CLIC Experimental Area Layout Design Considerations & ARUP Study

ARUP is a civil engineering consultant company that has been mandated by CLIC/ILC to perform the following study (splitted into task 1 & 2):

Task 2: Study the layout of the experimental cavern complex from a geotechnical standpoint, using the CLIC layout and CERN geology as reference model.

Caverns Moved Closer

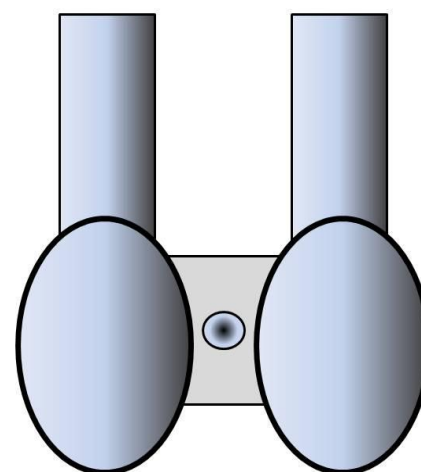
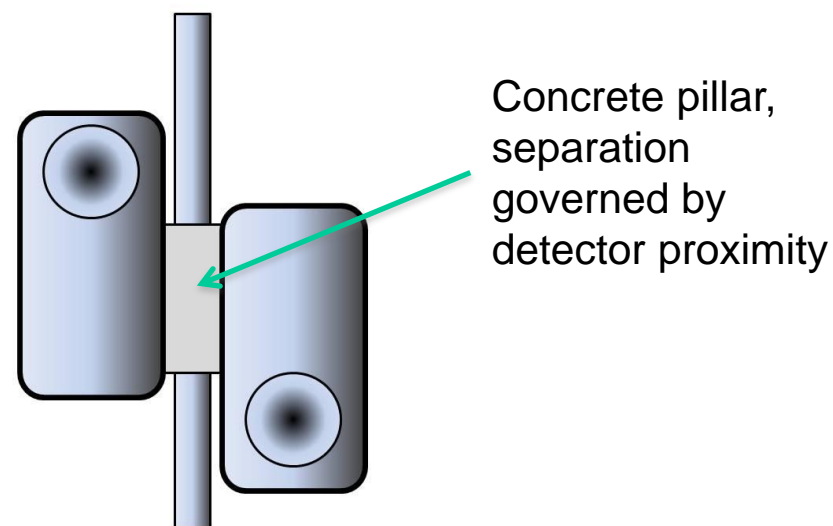
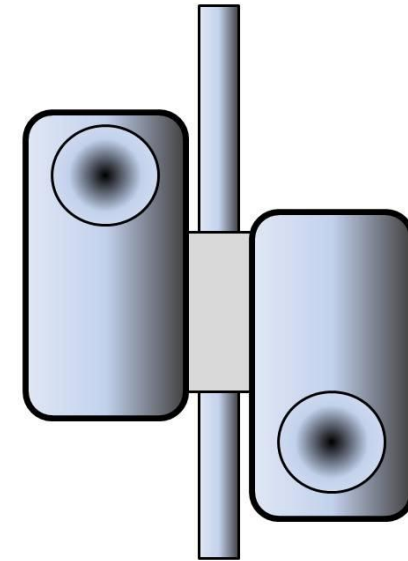
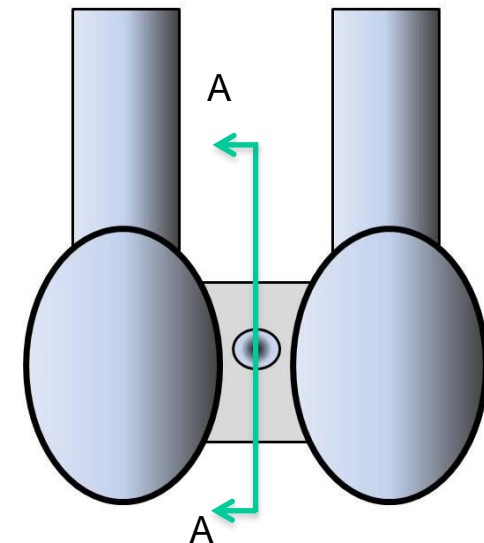
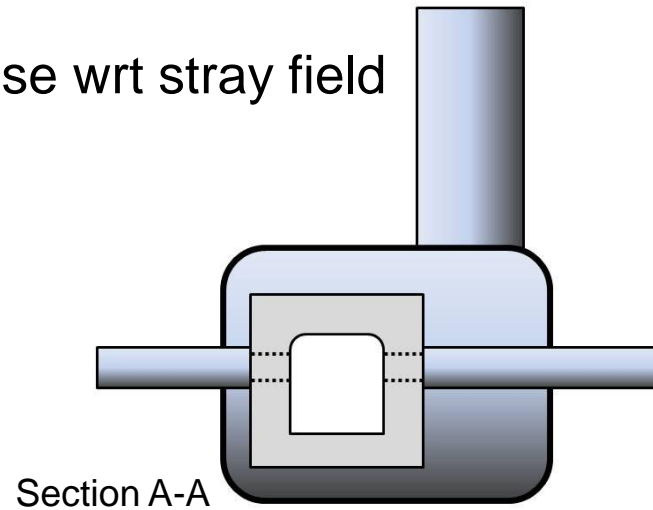
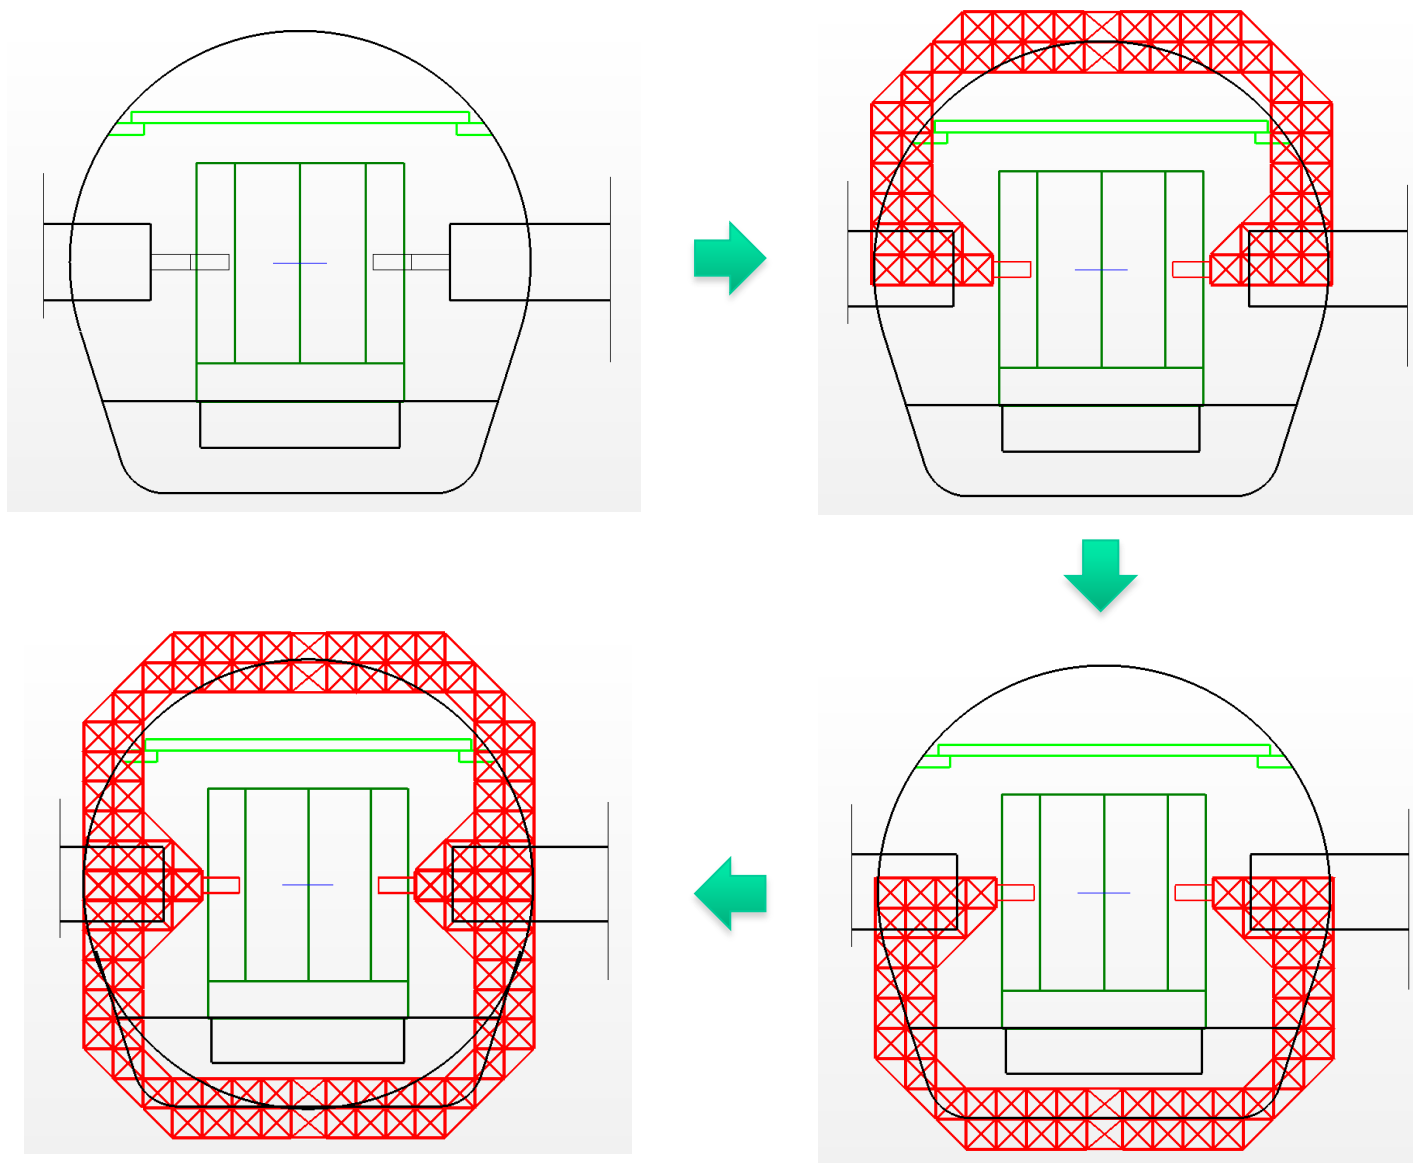
Potential Advantages:

- Reduces lining stress around caverns
- Slab foundations likely to be extremely stiff
- Vertical walls at IP, machine/detector
- Slab size potentially independent of detector width
- Minimum travel time and umbilical lengths

Potential drawbacks:

- Detectors too close wrt stray field
- ...
